# Staff Report

## Infill Housing Design Review Committee

File Number: 5-E-24-IH

**Location:** 3500 Gap Rd. **Parcel ID** 81 I S 028  
**Zoning:** RN-2 (Single-Family Residential Neighborhood)  
**District:** Lonsdale Infill Housing Overlay District

SITE PLAN

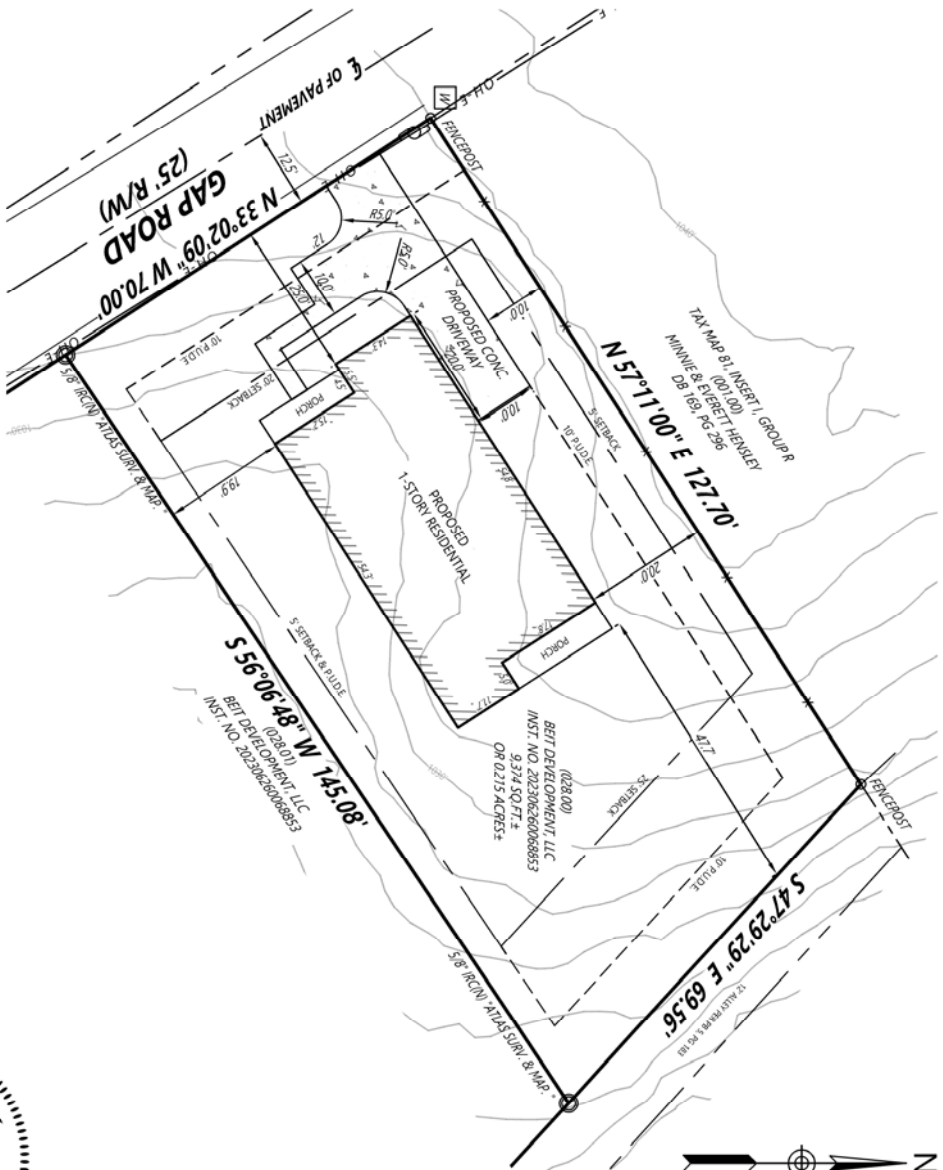
1. The house is proposed to be set 25' from the front property line. The block to receive new construction is relatively undeveloped; however, the existing houses on the block are set 15' and 18' from the front property line. The revised proposal has been aligned to align the four new houses on the block.

3. The application proposes a concrete driveway in the front of the house. Infill Housing guidelines recommend that on streets without alleys, parking areas should be at least 20' behind the front façade of the house with access limited to one lane between the street and the front façade. The turnaround may be required based on the site's topography and the conditions of Gap Road, but should be omitted if possible. Final site plans should meet City Engineering standards.

5. The revised application includes a 4'-5" deep entry stoop on the site plan and an 8' deep front porch on the floor plans. While an 8' deep porch meets the guidelines, the final site plan should include an accurate porch measurement.

9. Final site plans should include one native or naturalized shade tree in the front and rear yards. The lots currently feature a substantial amount of trees and other vegetation; existing trees should be retained if at all possible.

Front set back for each home will be normalized to create a consistent streetscape pattern.

Parking / driveway will be altered to meet guidelines

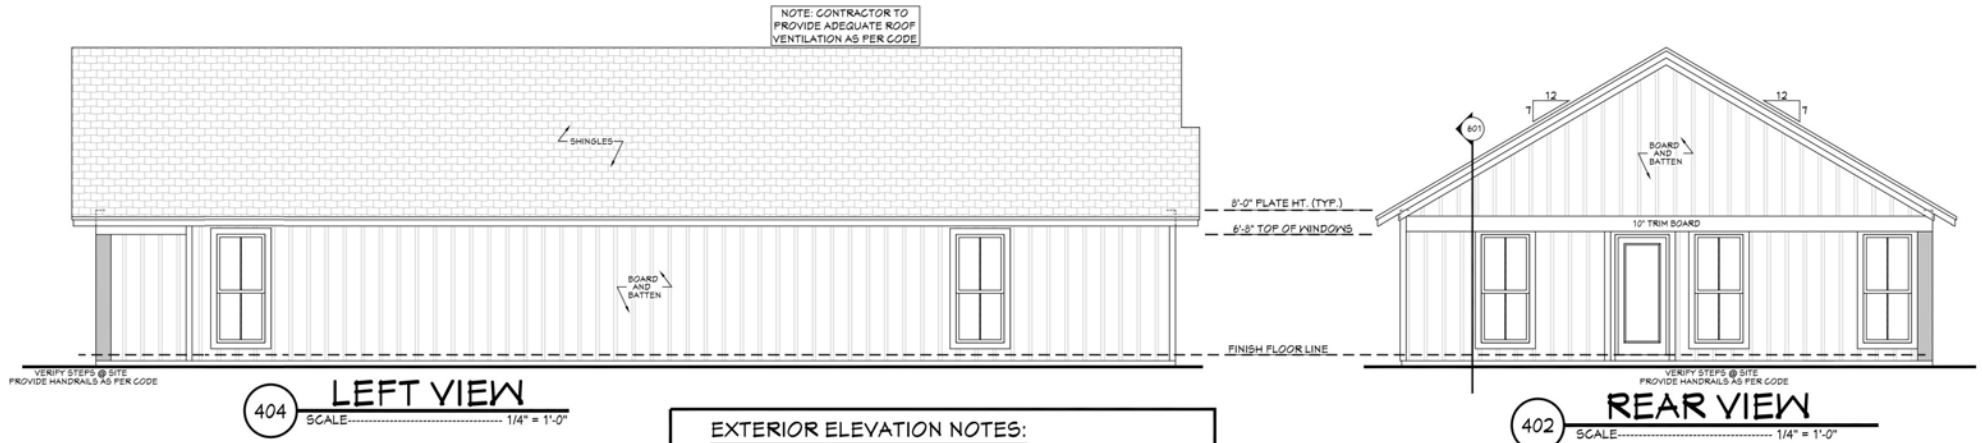
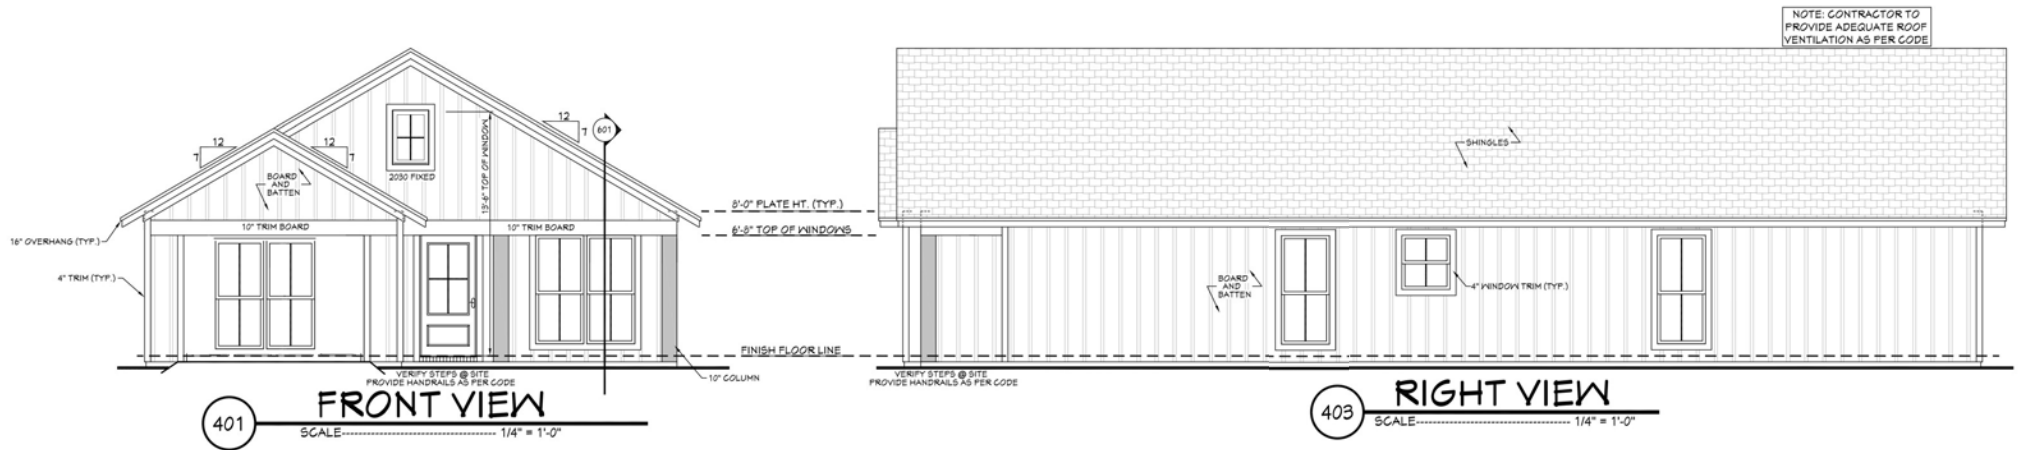
6. Guidelines recommend window and door styles be similar, with similar proportions and ratio of solid to void, to historic houses on the block and in the neighborhood. The revised application includes two windows on the left elevation and three on the right elevation.

7. The proposed roof pitch (7/12) meets the design guidelines.
8. The application does not include information on siding materials. Guidelines recommend that clapboard-like materials be used in new houses and discourages vertical siding; the houses should feature horizontal lap siding instead of board-and-batten. Final drawings should accurately show the siding to be installed.

10. The proposed new construction should be differentiated in design from the three other new houses proposed on Gap Road at the same time. Design tactics can include roofline modifications, different porch designs, or other methods. In response to the previous staff report and DRB decision (which was to postpone to allow the applicant to present revised drawings), the applicant has stated they will vary the houses via siding color and porch railings. The porch details are not shown on the drawings.

Siding will be horizontal lap siding

Exterior features will differ in siding color & porch railing and post types from adjacent homes

201 FOUNDATION PLAN  
SCALE: 1/4" = 1'-0"

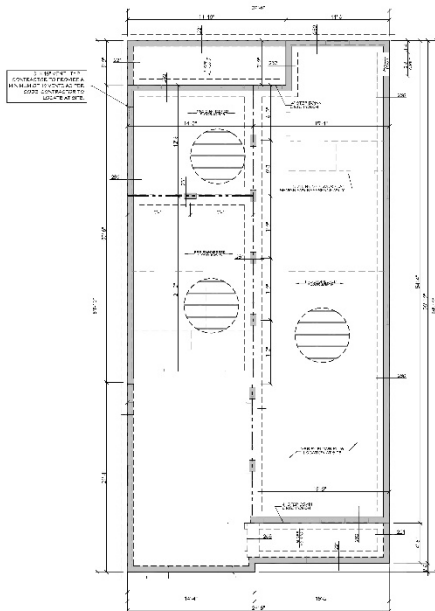
3) foundation to be elevated at least 12 inches to reflect historic houses in the neighborhood, with a revised foundation profile submitted to staff;

Foundation plan (below) does not specify a total height. Crawl space will exceed the 12 inch requirement
